DELTA-MENDOTA CANAL/ CALIFORNIA AQUEDUCT INTERTIE VOLUME 3: COMMENTS AND RESPONSES

**Delta-Mendota Canal/
California Aqueduct Intertie
Volume 3:
Comments and Responses**

Jones & Stokes
2600 V Street
Sacramento, CA 95818-1914
Contact: Craig Stevens
916/737-3000

April 2005

**Intertie Project Effects on CVP Returns to San Joaquin River
(2020 Level of Development)**

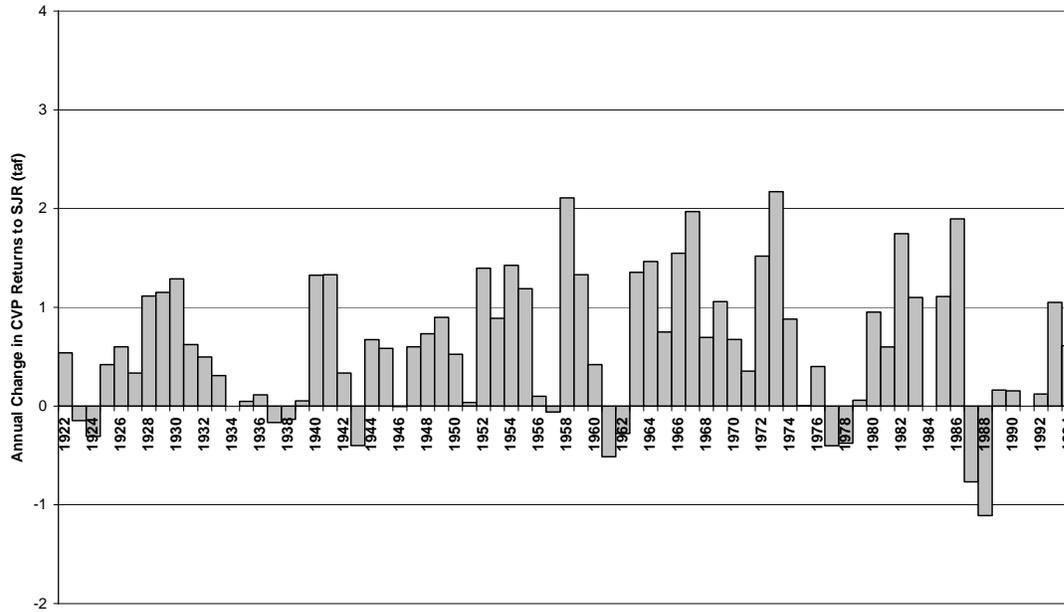
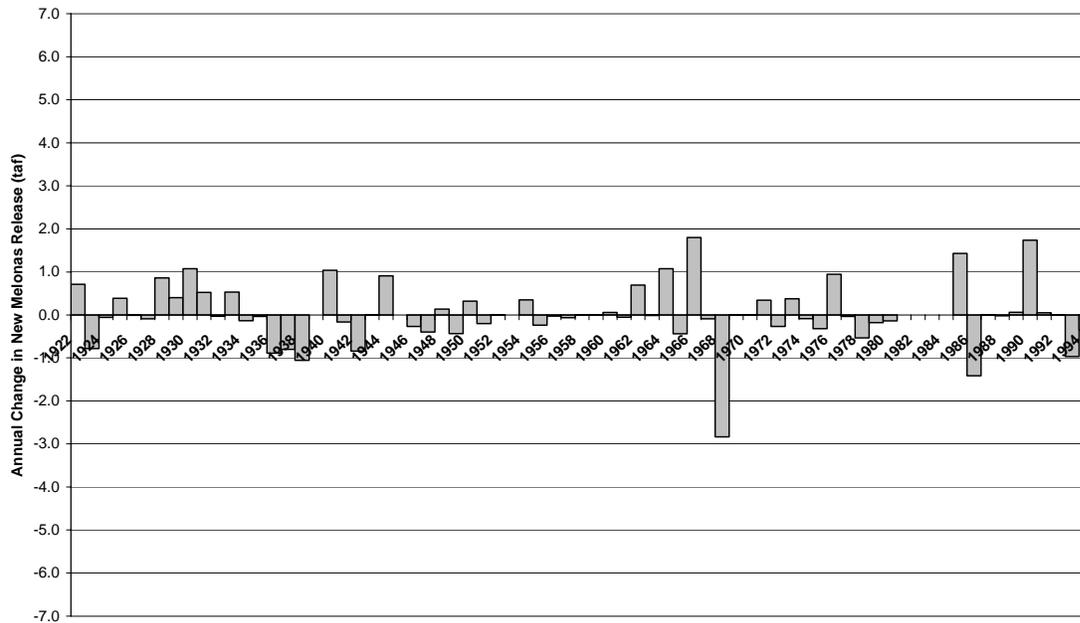
SEWD-9

The CALSIM II model dynamically responds to changes in agricultural drainage from DMC contractors (agricultural, refuge, and Exchange) to the San Joaquin River. Additional releases from New Melones are made if necessary, and if the maximum annual water quality release cap is not exceeded, to achieve Vernalis EC standards. Simulated CVP contractor return flows to the San Joaquin River for the Base and Intertie studies are shown in the figures below. The average annual returns in the Base are over 100 taf/yr. Simulated changes in return flows to the San Joaquin River are less than 2 taf/yr. As a result of this small change in return flow, the contribution to increased salt load to the San Joaquin River at Vernalis is small. Annual New Melones releases in the Base average to approximately 1004 taf/yr. Simulated annual average New Melones releases with the Intertie are also 1004 taf/yr. The attached plot (New Melones Summary sheet) indicates that while the average annual release is the same, changes may occur, per individual year, in New Melones releases. However, these release changes are generally less than 5 taf/yr.
